JERICO IMEX LTD. (Extention 2)

15 April 2026

Observation-02: Appearance of corrosion in steel section. (Finishing Shed).

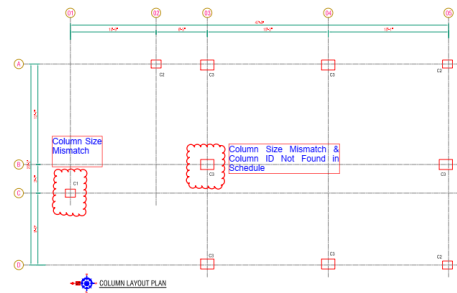
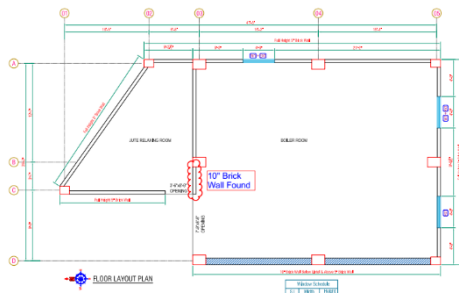
Description: Appearance of corrosion observed at the bottom of steel columns during inspection. The building engineer is required to carry out periodic maintenance and implement necessary corrective measures to prevent further progression of the corrosion.

Observation-04: Mismatch found in-between provided as-built drawing and actual site condition. (Boiler Building).

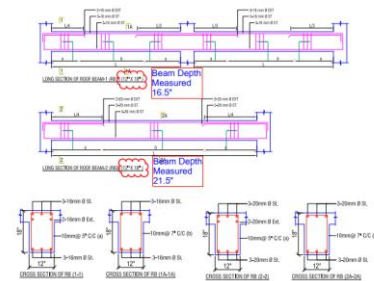
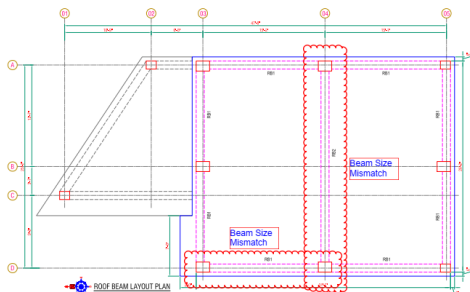
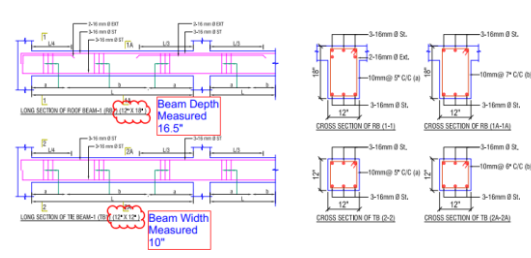
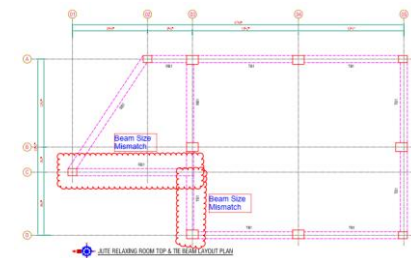
Column ID C3 is Missing

Description: Mismatch in between as-built drawings and actual site condition observed in multiple locations. E.g. 10"thick brick wall observed in floor layout plan at grid 3-B~C, but 5" wall is shown in the as-built drawing. Column size mismatch observed in C1 and C3 column. In addition, C3 ID was missing in the column schedule in as-built drawing. Beam size mismatch found in Beam ID RB1, RB2 And TB1 at different locations.

The building engineer is required survey the whole structure and address all the discrepancies in the as-built drawing and correct it accordingly.

Observation-06: Crack observed in Boundary wall.

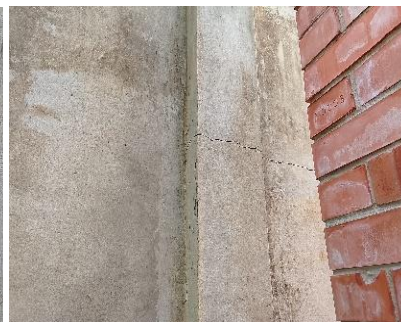
Description: Diagonal and horizontal cracks were observed at multiple locations on the boundary wall at sound side of the Finishing shed and back side of the Boiler building. The height of the wall was measured around 12 feet. The building engineer is required to investigate the cause of the cracks and implement appropriate remedial measures accordingly.
